BID FOR: Canal 10 Drainage Improvements
at West Esplanade Avenue
Jefferson Parish Department of Public Works
Project Number 2011-029-DR
Proposal No. 50-00123141

CANAL NO. 10 DRAINAGE IMPROVEMENTS AT WEST ESPLANADE
BID PROPOSAL NO. 50-00123141
ADDENDUM NO.1
DATE: 7/25/2018
PAGE 1 of 4

CANAL NO. 10 DRAINAGE IMPROVEMENTS AT WEST ESPLANADE
BID PROPOSAL NO. 50-00123141
ADDENDUM NO.2
DATE: 7/26/2018
PAGE 1 of 2

BURK & ASSOCIATES, INC.
ENGINEERS
NEW ORLEANS, LA.
JOB NO. 6415-C
DATE 10-1-58
SCALE NOTED
SHEET NO. 10 OF 50

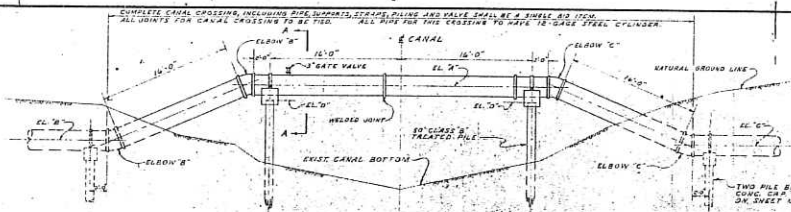
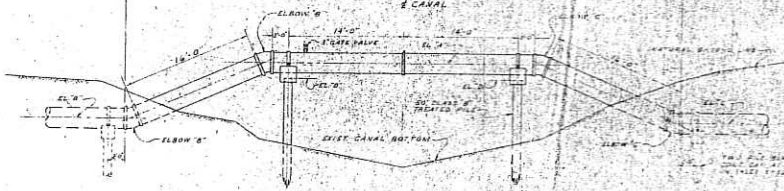
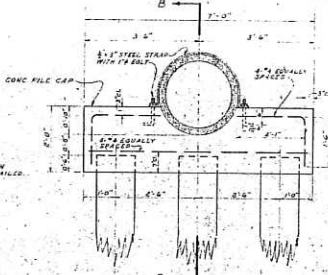
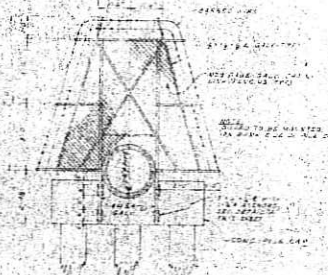
- (A) Yes.
- (Q) Please provide details of the existing bents that need to be removed. How many piles per bent? What is the bent caps dimensions and type of material?

- (A) See reference drawing attachment No. 2 of this addendum for existing bents to be removed.
